To: T10 Technical Committee
 From: Bob Sheffield (robert.l.sheffield@intel.com)
 Date: 1 June 2006
 Subject: 06-262r1: SAT - Example Configurations

Discussion of letter ballot comments in subclause 5.1, the Architecture Overview, led to direction to copy and modify figures from the VPD pages showing basic usage models for SAT into the Architecture Overview showing the three examples listed. This proposal shows the suggested changes, and is intended to resolve letter ballot comments in subclause 5.1 related to the example implementations.

Figure 5 — SATL contained within a SCSI target device

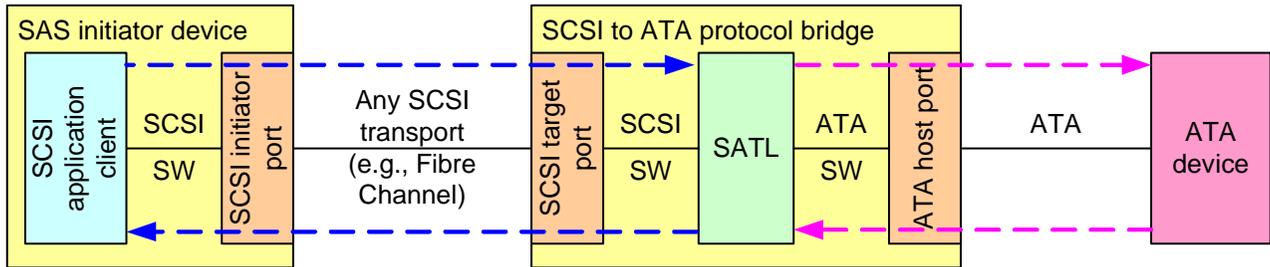
EXAMPLE 1 - Figure 5 shows a SATL contained within a SCSI target comprised of ATA devices and/or ATAPI devices using a defined SCSI transport protocol (e.g., Fibre Channel, SCSI parallel interface, or SBP-3).

Figure 6 — ATA HBA directly connected to ATA devices and/or ATAPI devices

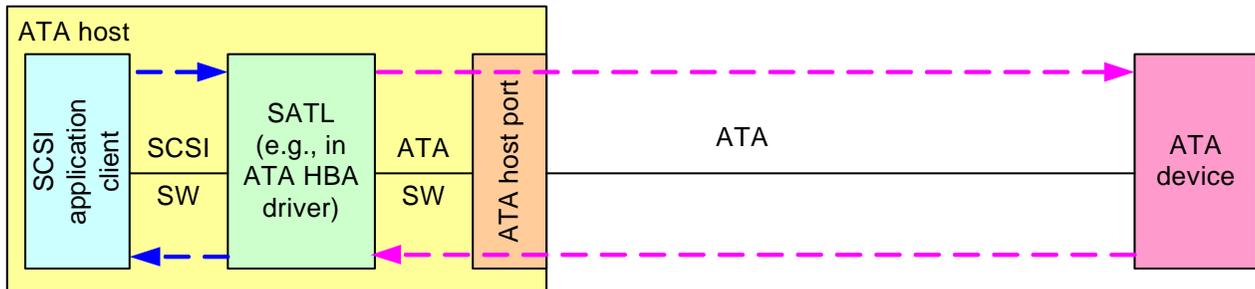
EXAMPLE 2 - Figure 6 shows an ATA Host Bus Adapter (HBA) directly connected to ATA device(s) and/or ATAPI devices, and providing SCSI transport protocol layer services to a SCSI application client in accordance with SAM-3.

Figure 7 — SAS STP initiator port connected to ATA devices and/or ATAPI devices

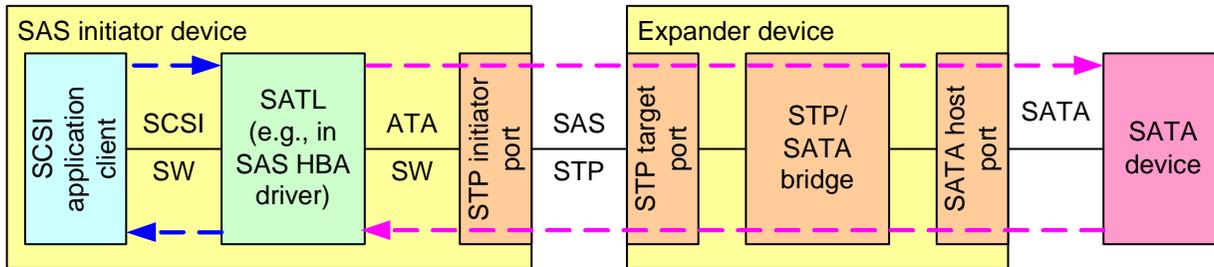
EXAMPLE 3 - Figure 7 shows a SAS STP initiator port (see SAS-1.1) connecting to ATA devices and/or ATAPI devices. The STP initiator port includes a SATL to provide the SCSI transport protocol layer services to the application client.
